**FINAL REPORT**  
**TOTAL SYSTEM PERFORMANCE ASSESSMENT**  
**PEER REVIEW PANEL**  
**February 11, 1999**

Peer Review of the  
Total System Performance Assessment-Viability Assessment

Final Report

**Figure IV-1. Calculated seepage fraction and seep flow rate as functions of percolation flux (Figure 3-13 of TSPA-VA).**

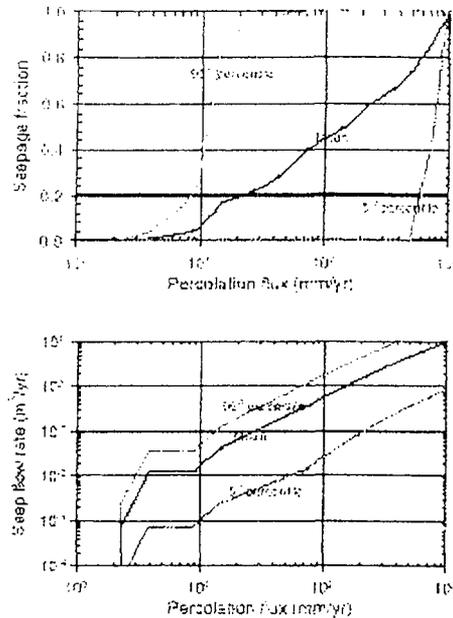
Figure 3-13 of the TSPA-VA, for example, shows that for a wide range of percolation flux values, the variance in the seepage fraction is almost equal to its mean value. It is not surprising therefore, that seepage into drifts was found to be one of the most sensitive parameters in the final dose results in the TSPA-VA report.

Of interest is the predicted sensitivity of the seepage fraction on the percolation flux for values above the threshold and below 10 mm/yr, as shown in Figure 4-3 in Volume 3 of the TSPA-VA (CRWMS M&O, 1998d). On the basis of data presented in this figure, it follows that predictions of the fraction of wet canisters under present-day infiltration, which falls in this range, will be subject to relatively large uncertainties. This underscores the need for an accurate estimate of the magnitude of the percolation flux. In the long term, the effect of percolation rate, *per se*, on seepage cannot be estimated with a large degree of accuracy, given the uncertainties in long-term climate predictions.

The Panel believes that the analysis of seepage is an important new contribution. However, because the sensitivity of the seepage estimates depends on the permeability and capillary structure of the fracture continuum in the immediate neighborhood of the drifts, they are subject to the large uncertainty in our knowledge of the heterogeneity, spatial correlation and anisotropy of these properties. For example, Figure IV-1 (Figure 3-13, CRWMS M&O, 1998d) shows that for a large range in the percolation flux, the variance in seepage fraction is large (and almost equal to its mean value). It is not surprising, therefore, that seepage into drifts is one of the most sensitive input parameters in estimating dose rate in the TSPA-VA.

1. Since capillary barriers essentially reflect boundary effects, seepage would be sensitive to the particular geometric and wetting conditions in a small region around the drift wall. The need exists, therefore, for an accurate characterization of the heterogeneity and fracture capillary properties in this area. The effects of the geometrical changes that may result from the collapse of the drift roof in response to thermomechanical or seismic processes need to be analyzed. In addition, given that the actual fracture spacing is of the same order as the grid block size used in the continuum DKM model for the seepage study (grid spacing of 0.5 m), the use of discrete fracture models of transient flow would be more appropriate and should be pursued. The results from such investigations would also be useful to thermohydrology (TH) and thermochemical (THC) models that are to be used for assessing conditions during the thermal period.

2. Although recent experimental data are reported to be consistent with the seepage analysis, further testing is needed. A better characterization of the hydrologic properties near the drifts, an analysis of transient flow based on a discrete fracture network, and additional experimentation at the drift scale would test the model predictions and would help increase confidence on the TSPA-VA results. Efforts in these directions are currently under way.

3. In the TSPA base case, seepage into the drifts is decoupled from TH, and is assumed to only take place following the end of the thermal period and under ambient flow conditions. The model also assumes that seep locations and rates are time-independent, under conditions of constant climate, and that the drift geometry remains constant. Many of these assumptions will not be valid. As has recently been confirmed in the Large Block Test (Hardin, 1998), the possibility of episodic seepage events during the thermal period, as a result of instabilities, cannot be excluded. During the period of the thermal pulse, which is expected to last for several thousand years, thermomechanical and thermochemical effects on the permeability and capillary structure of the fracture network will alter seepage patterns as a function of time. In addition, drift collapse, as a result of thermomechanical or seismic events, will alter seepage patterns, rates and any accompanying contact of waste packages with water.

**Figure IV-3. Development of precipitate cap over repository as indicated by fracture porosity ratio change (from Hardin, 1998).**

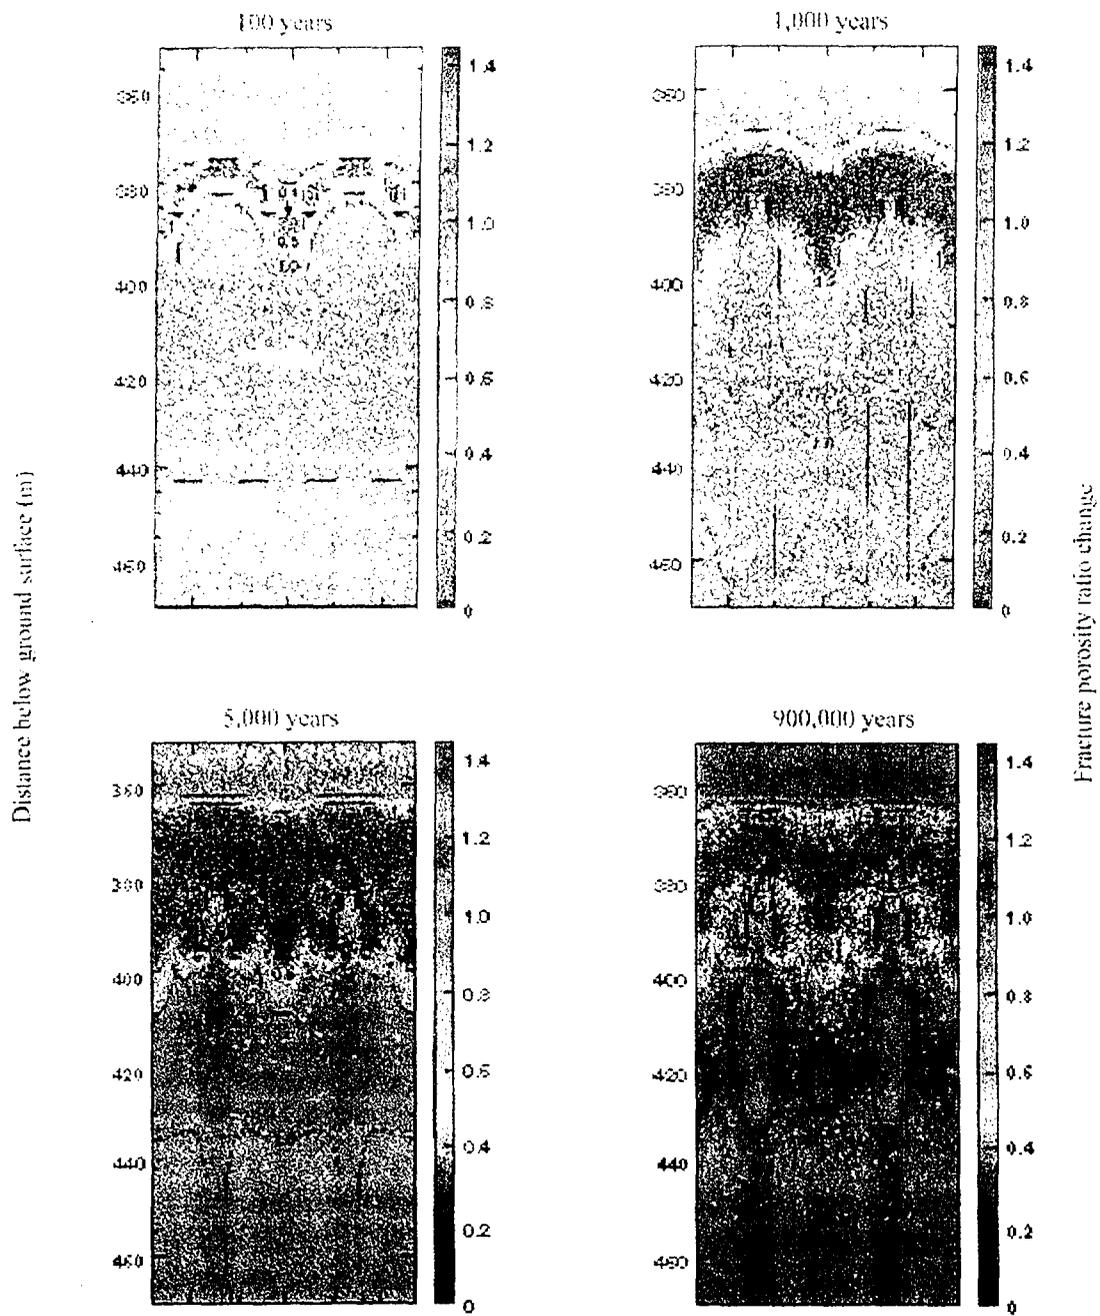
This dissolution of minerals at one point in the fracture network, and their redeposition at another could lead to the formation of a precipitate cap over the repository that varies in thickness as shown in Figure IV-3 (adapted from Hardin, 1998). The presence of the precipitate cap is indicated by the areas, primarily overlying the repository, where the fracture porosity ratio has decreased to 0.1 or less. For the base case, the initial fracture porosity at the level of the repository was taken as  $\phi_0 = \sim 10^{-4}$  (Hardin, 1998). Thus, the model results indicate that the fracture porosity of the cap has been reduced to  $\phi = \sim 10^{-5}$ . Note that by 100 years time, the formation of the cap has started, and that by 5,000 years, the cap has reached its maximum thickness. This indicates that heat pipe activity continues well beyond 1,000 years.

It is important to realize that the process of dissolution is much slower than the process of precipitation, and as a result, a cap of significant thickness is projected to still be present after thousands of years (indicated in Hardin [1998] to last as long as 900,000 years). Thus, the properties of the cap in controlling seepage into the EBS, and eventually onto the canisters is of critical importance to the problem of establishing how the environment of the repository will change over time and how this will affect the distribution and quantity of water flowing through the repository.

In the THC analysis that led to the development of a precipitation cap (Figure IV-3), it was necessary to evaluate the changes in porosity that would result from the deposition of minerals on fracture surfaces. The accumulation of such material would tend to reduce the fracture porosity and the permeability as well. The intrinsic permeabilities in the fracture and matrix continua were assumed to scale as the cube of the porosity. It was stated that this, "...is equivalent to cubic law if the fracture aperture is assumed to vary linearly with the porosity of the fracture continua." (Hardin, 1998).

Figure IV-4. Logic diagram for waste package degradation model (Figure 3-44, TSPA-VA).

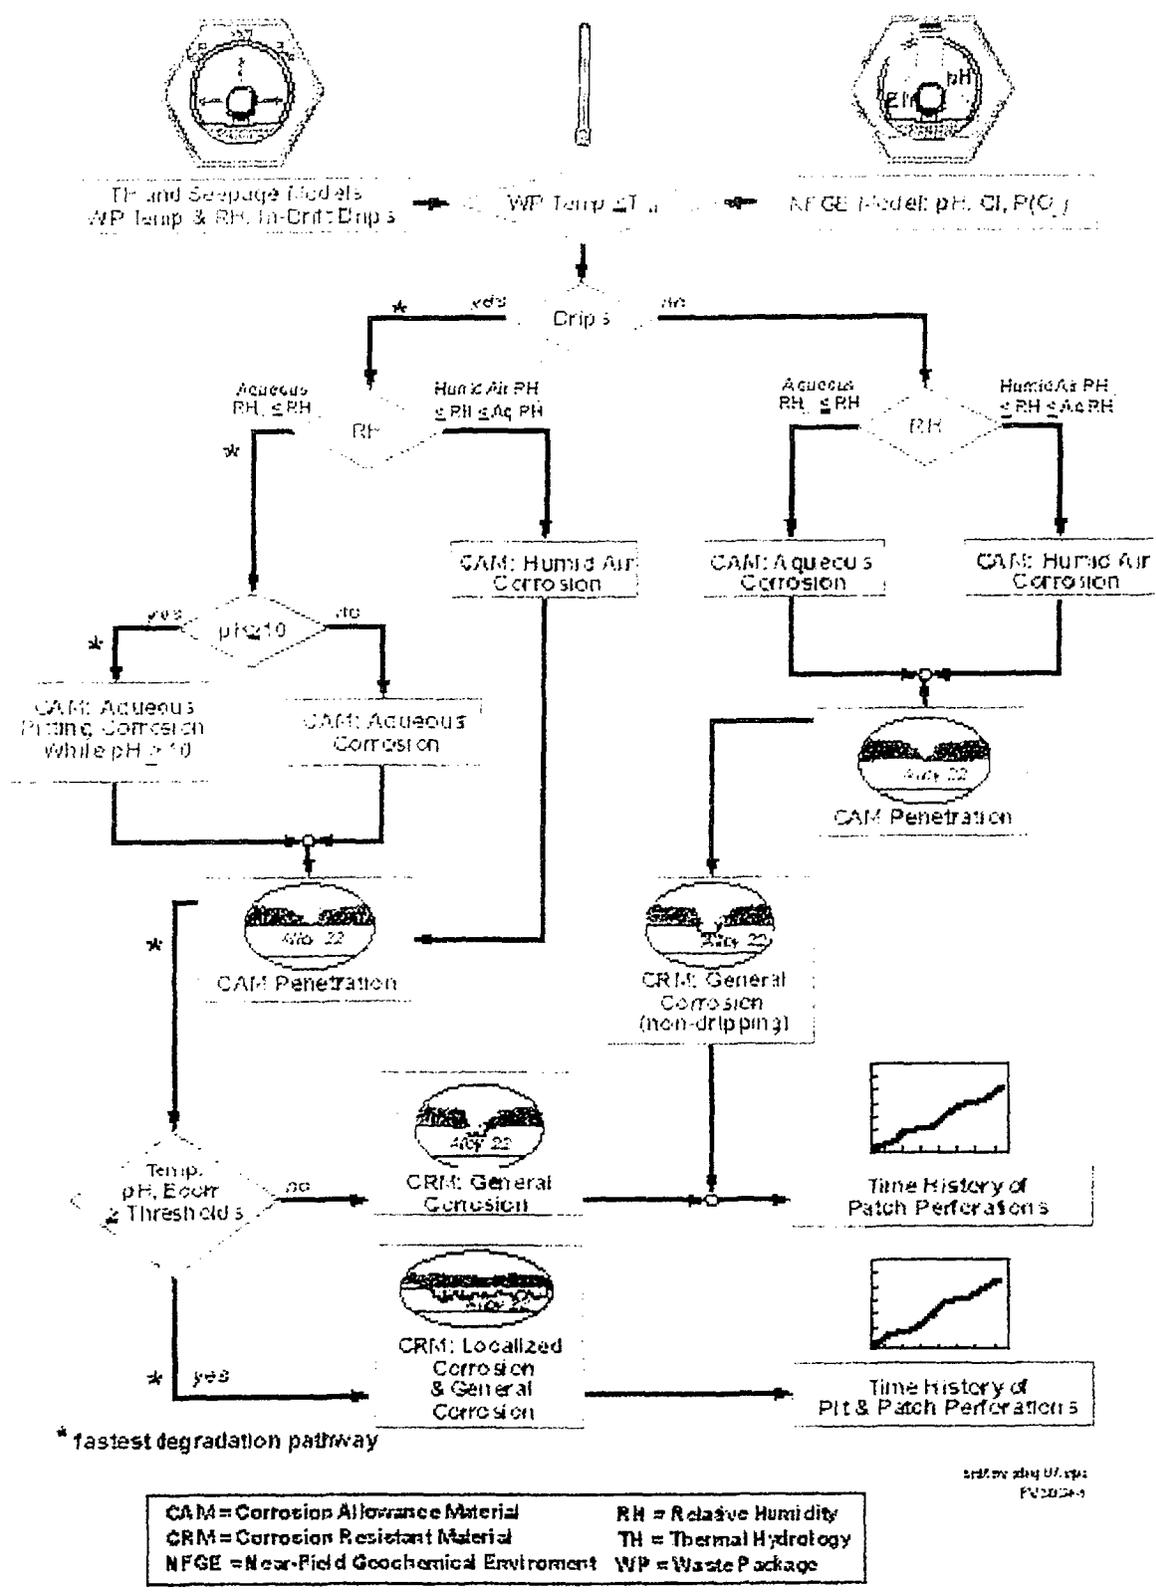
The complexity of the WAPDEG Model for waste package degradation is illustrated in Figure IV-4, the WAPDEG Model Logic Diagram. One of the characteristics of this model is that it incorporates a series of individual corrosion submodels that are organized

in a decision tree mode. These are designed to analyze the corrosion behavior of steel, a corrosion allowance material (CAM), and C-22, a corrosion resistant material (CRM), respectively. The cumulative depth of penetration for the outer steel barrier is determined through a series of time steps. When the total penetration within a patch equals the outer barrier thickness, the inner barrier of CRM is assumed to be exposed to the environment and the CRM models are then used to estimate the cumulative penetration of this barrier. The waste package is assumed to be breached when both barriers are estimated to have been penetrated by corrosion. The Panel concludes that this treatment is logical; however, major information needs remain, especially in anticipation of the possible LA phase.

There are advantages and disadvantages to the complexity of the WAPDEG model. Among the advantages are that it has the potential for more realism in the analyses, and that it permits flexibility in the treatment of processes that have spatial and temporal changes. The complexity of the model will also provide the option for flexibility in treating additional aspects of corrosion behavior. This will be especially true as additional data are obtained and the understanding of the TSPA analysts improves. At the same time, however, the WAPDEG model has clear disadvantages. These include a loss of transparency, difficulties in tracking the decisions and assumptions made and the impacts of these on model outputs, and an increase in the need for supporting data and knowledge that may not be available (or may not be obtainable). In addition, the complexity associated with the model can mask uncertainty.

**Figure IV-5. Information needs for the waste package degradation model-WAPDEG (Figure 5-5 Chapter 5 of Technical Basis Documents).**

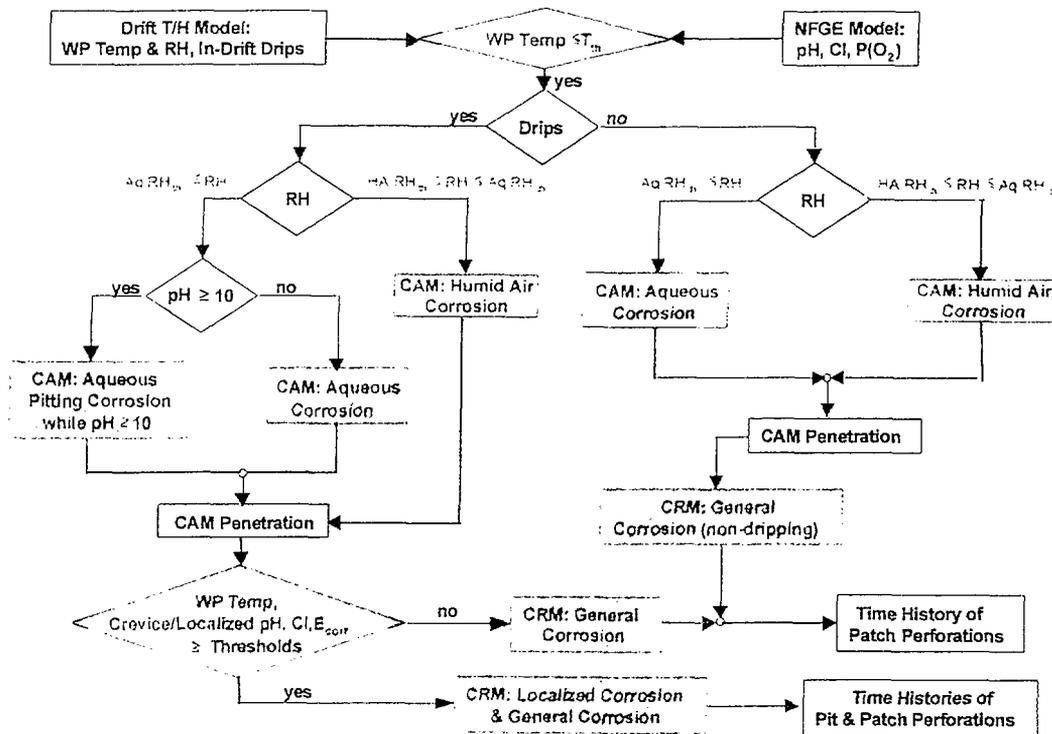
The information needs for the individual corrosion models within the WAPDEG model are identified in Figure IV-5. These needs include information regarding the environment (e.g., temperature, relative humidity, pH and Eh), and information regarding the corrosion behavior of the metals (e.g., critical temperatures for localized corrosion, and corrosion rates over a range of conditions). Because of a lack of data for the various input parameters, the TSPA-VA staff depended to a large extent on expert elicitation. The
